**STAFF RECOMMENDATION**

**906 Boscobel Street  
January 20, 2016**

**Application:** New construction--infill  
**District:** Edgefield Historic Preservation Zoning Overlay  
**Council District:** 06  
**Map and Parcel Number:** 08216034800  
**Applicant:** Brad Sayers, Four Square Design Studio  
**Project Lead:** Paul Hoffman, paul.hoffman@nashville.gov

**Description of Project:** New construction of a single-family residence. A Specific Plan (SP) was approved for the site in 2013 permitting a second structure on the property.

# PRELIMINARY PLOT PLAN

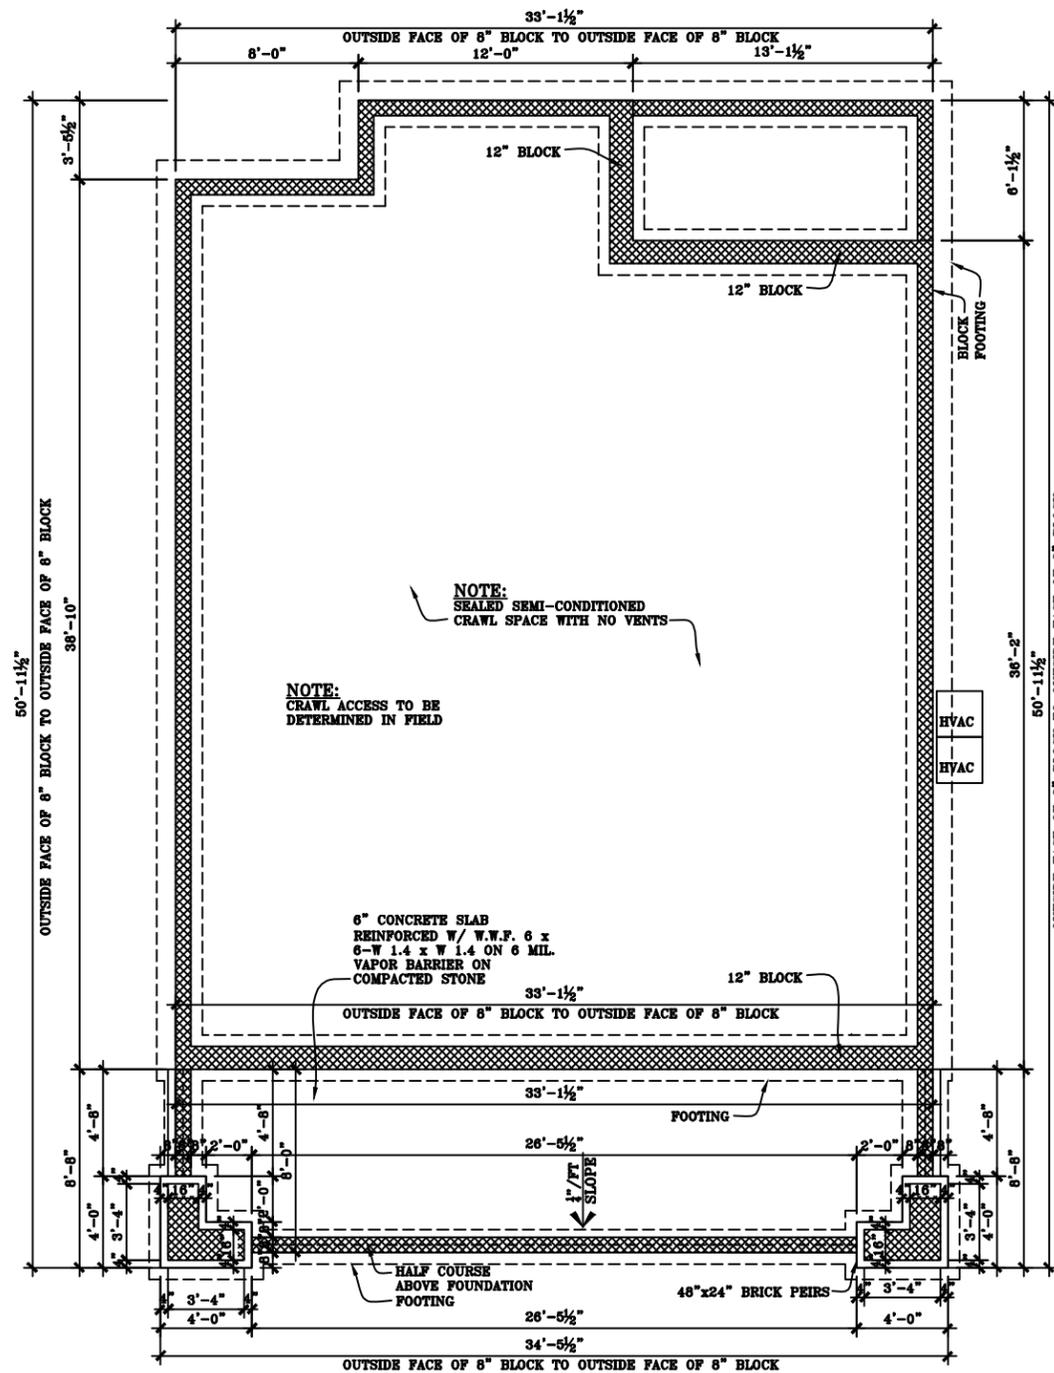
Setbacks and Rhythm of Spacing: The front setback is twenty-nine feet from the front property line (29'), which is the average of the adjacent homes. The new house will be approximately fifty feet (50') from the existing one. The side setbacks are five feet, six inches (5'6") on the left, and approximately eleven feet (11') on the right. The rear wall of the house will be approximately ninety-two feet (92') from the rear property line. The proposed setbacks meet bulk zoning, and the project meets section III.B.2.a of the design guidelines.

Orientation: The front door and porches of the house address Boscobel Street. The front porch is eight feet (8') deep. A walkway leads from the porch to the street. The site plan for the project shows a driveway from the alley to a new parking pad for the new building. Parking for the existing home is not indicated. The new building will be visually compatible with surrounding historic structures, and meets section III.B.2.e.

**FRONT ELEVATION**  
SCALE: 1/4" = 1'-0"

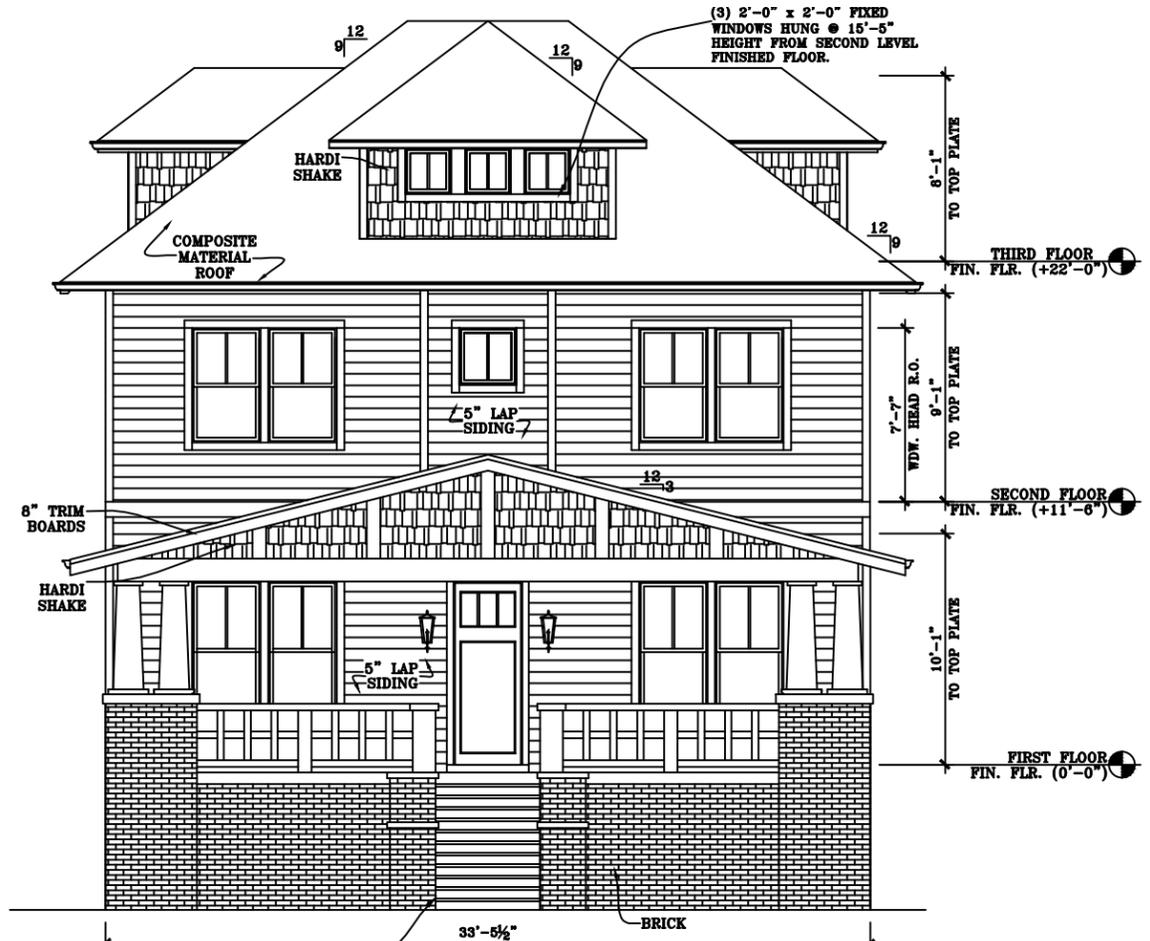
Height & Scale: The new building will be thirty-seven feet, seven inches (37'7") from grade at the front, as the grade slopes to the street. Contributing homes in the vicinity range from eighteen feet (18') to thirty-eight feet (38') in height. The foundation height is four feet (4'), which is typical for homes on this side of the street. As drawn, the porch steps up from the foundation height approximately one foot (1'). As this accentuates the building's perceived height, Staff recommends verifying that the material change between the foundation and the first floor occur at the finished floor height. This is in accordance with the italicized information in section III.B.2.g, "*When different materials are used, it is most appropriate to have the change happen at floor lines.*" The building will be thirty-three feet, five inches (33'5") wide. The context ranges from twenty-eight feet (28') to forty feet (40') wide. With Staff's verification of the finished floor height, the proposed new building meets section III.B.2.b.

Proportion and Rhythm of Openings: The windows on the proposed addition are generally twice as tall as they are wide, meeting the historic proportions of openings. There are no large expanses of wall space without a window or door opening. Staff finds the project's proportion and rhythm of openings meet Section III.B.2.f.

Materials, Texture, and Details and Material Color: The new building will be clad in smooth face cement fiberboard with a reveal of five inches (5"). The trim will be wood. The foundation will be split-faced concrete block, and the roof will be composite shingles. The porch foundation and column bases are brick; Staff requests approval of a masonry sample for dimensions, color and texture, prior to purchase. Porch columns and railings will be wood. The window schedule lists most of the windows as Pella Proline, which is a model of wood double-hung windows that has been approved by the MHZC in the past. Staff recommends approval of the final window and door selections prior to purchase and installation. The porch gable field and dormers will be clad in cement fiberboard shingles. With the staff's final approval of the windows and doors, roofing color and masonry, staff finds that the materials meet Sections III.B.2.g.

1. The finished floor height shall be consistent with the finished floor heights of the adjacent historic houses, to be verified by MHZC staff in the field;
2. Staff approve the final details, dimensions and materials of windows and doors prior to purchase and installation;
3. Staff approve the roof color and masonry color, dimensions and texture.

**ROOF SCHEMATIC**  
SCALE: 3/32" = 1'-0"

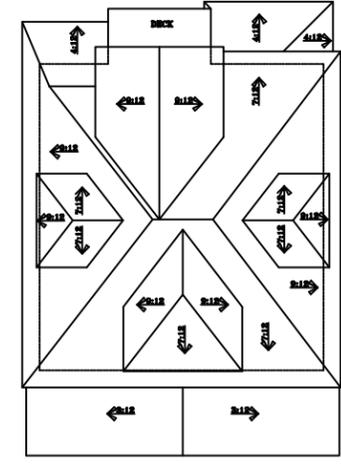
Building Shape and Roof Shape: The proposed building is a four-square design. Its hipped roof has dormers on all four sides of the roof. The roof pitches are 9/12 and 7/12. The building form and roof forms are commonly found historically and are appropriate for the context. The project meets sections III.B.2.c and d of the design guidelines.
